**RE: Defined Fitness at Unser Crossing  
Grading and Drainage Plan  
Engineer's Stamp Date: 01/23/19  
Hydrology File: K10D045**

**RE: Defined Fitness at Unser Crossing  
Grading and Drainage Plan, and Drainage Analysis Report,  
Engineers Stamp Dates 1/23/2019 and 1/28/2019  
Hydrology File: K10D045**

**DEFINED FITNESS UNSER CROSSING**

**GRADING AND DRAINAGE PLAN**

Designed: CP	Drawn: DR, CP	Checked: DMG	Sheet: C-1
Scale: 1"=30'	Date: 1-21-2019	Job: 15056

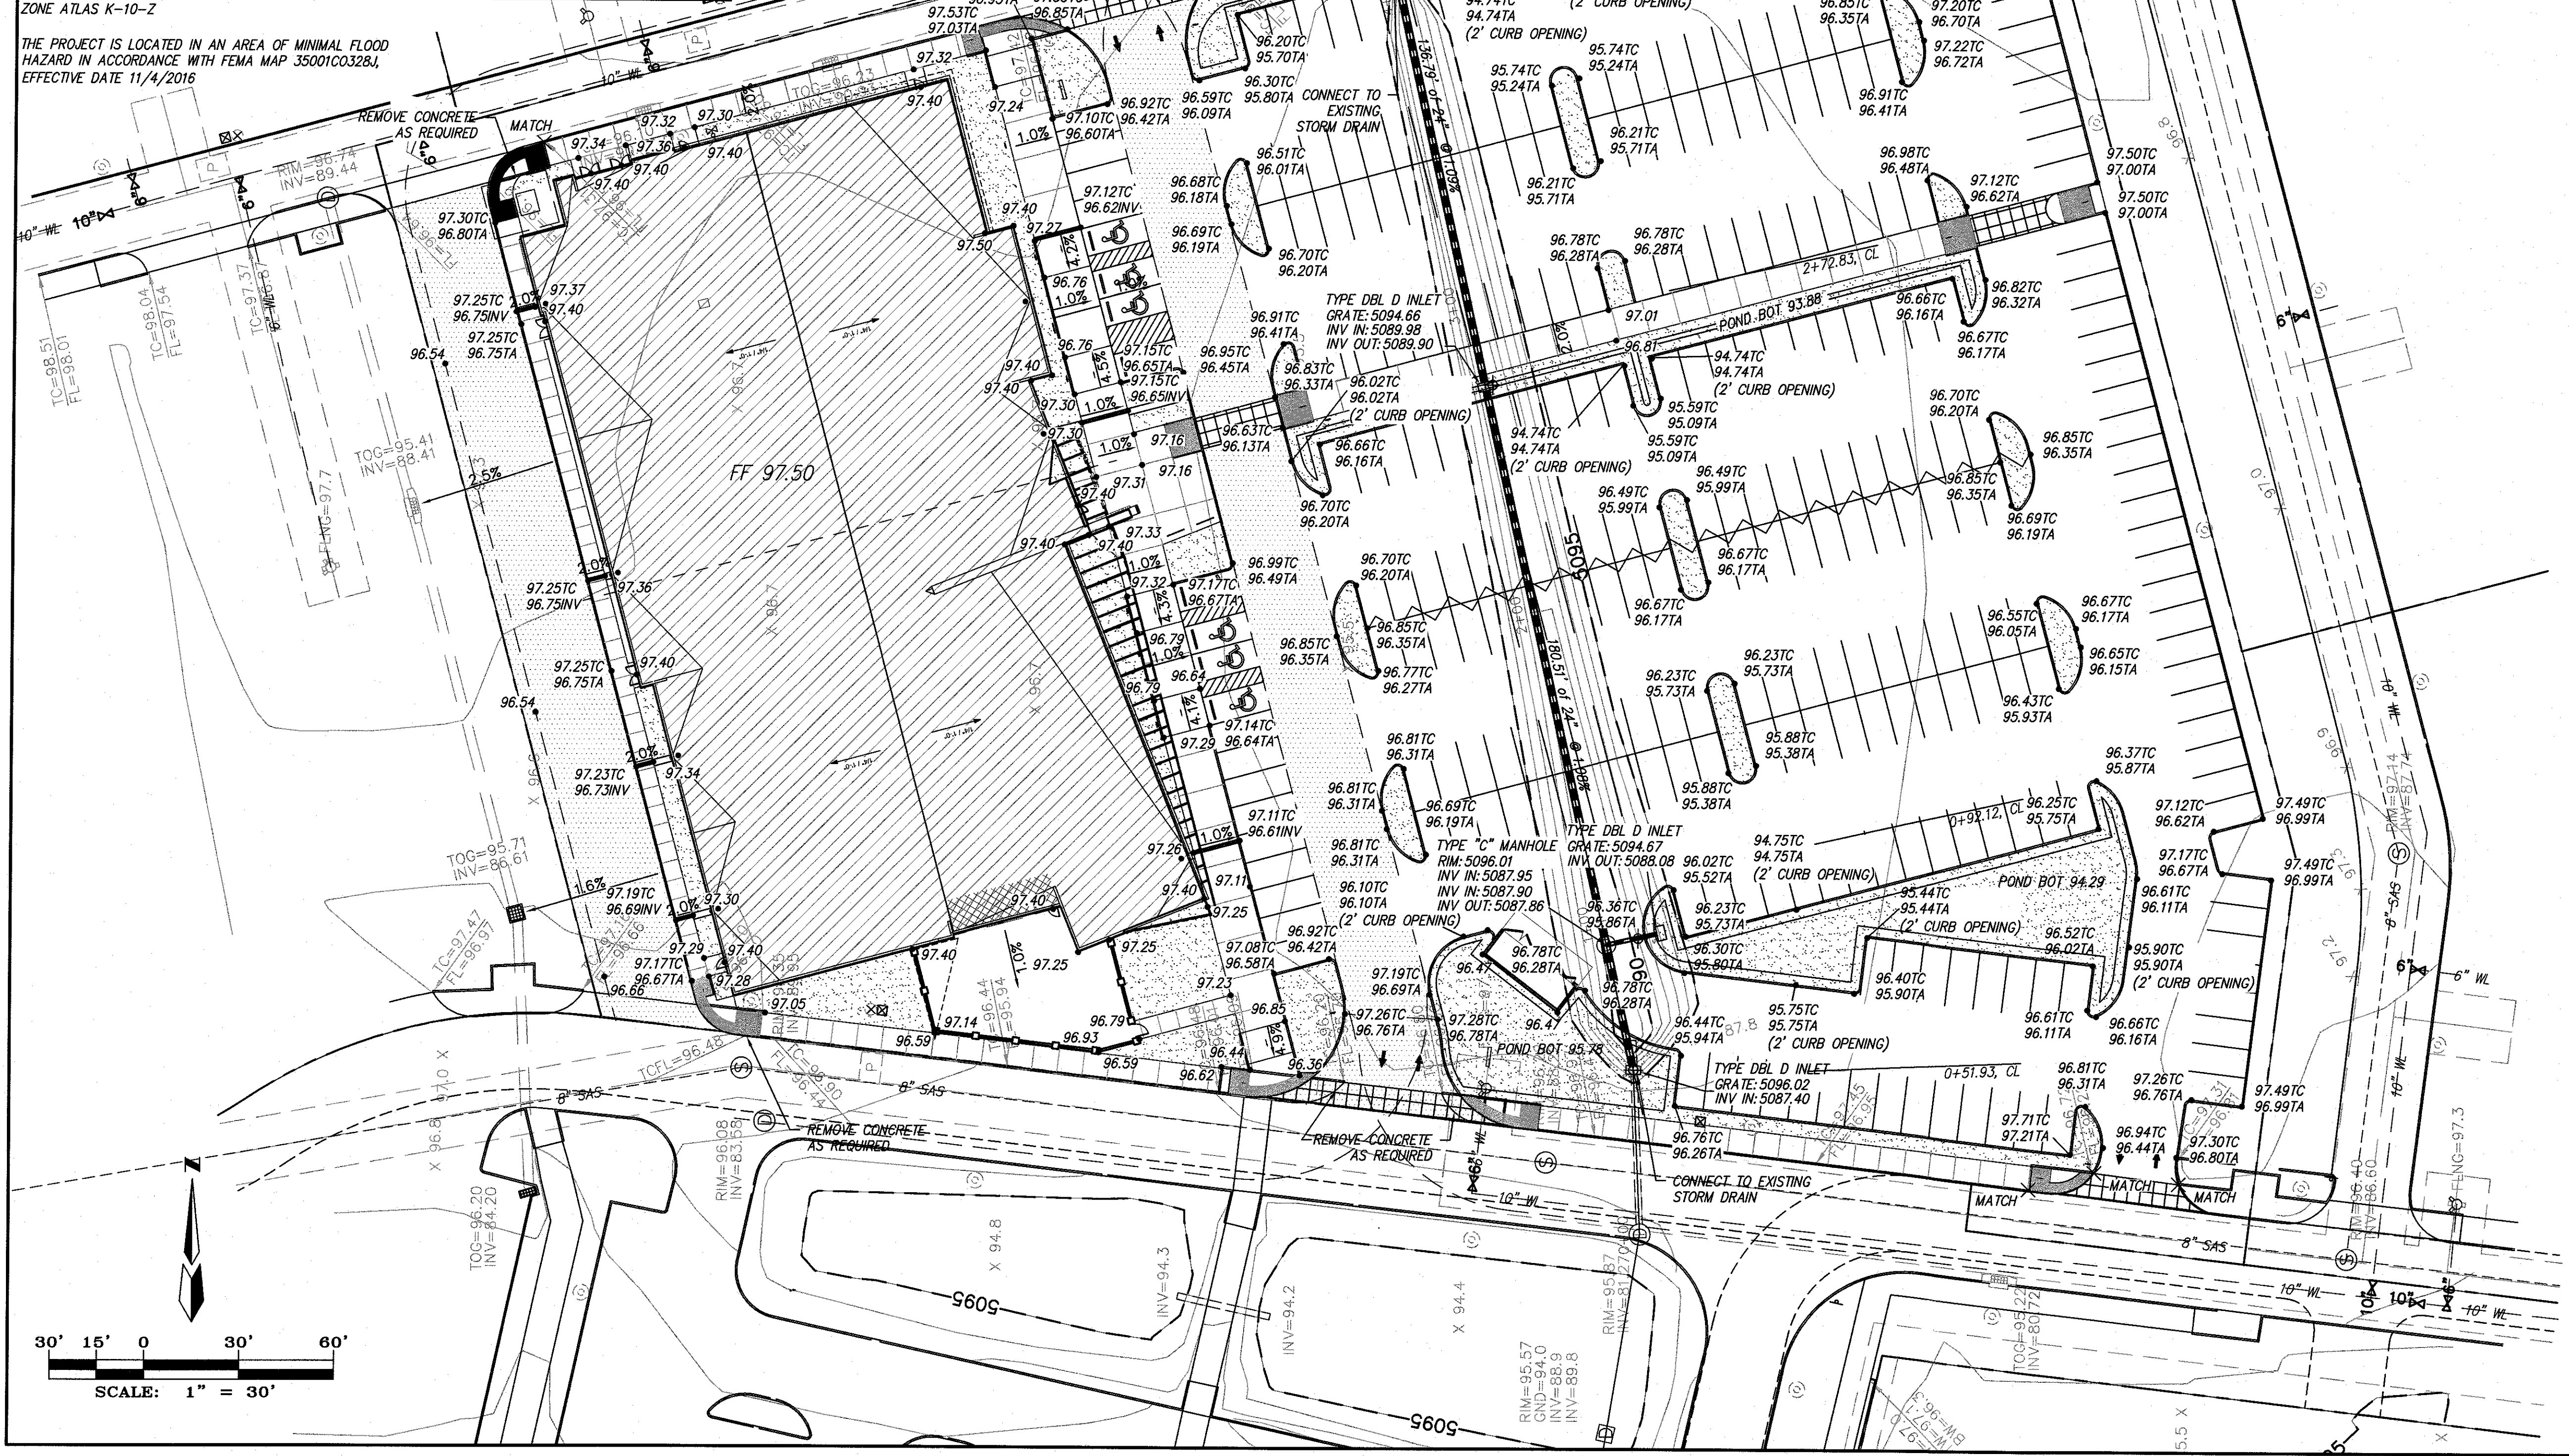
In response to correspondence dated January 10, 2019, please find enclosed revised Sheet C1, C2, and bound Drainage Analysis Report. Sheet C1 includes revisions of the bottom elevations of the First Flush ponds. Sheet C2 is revised with the corresponding changes to the accountancy of First Flush. Also, the title blocks were changed.
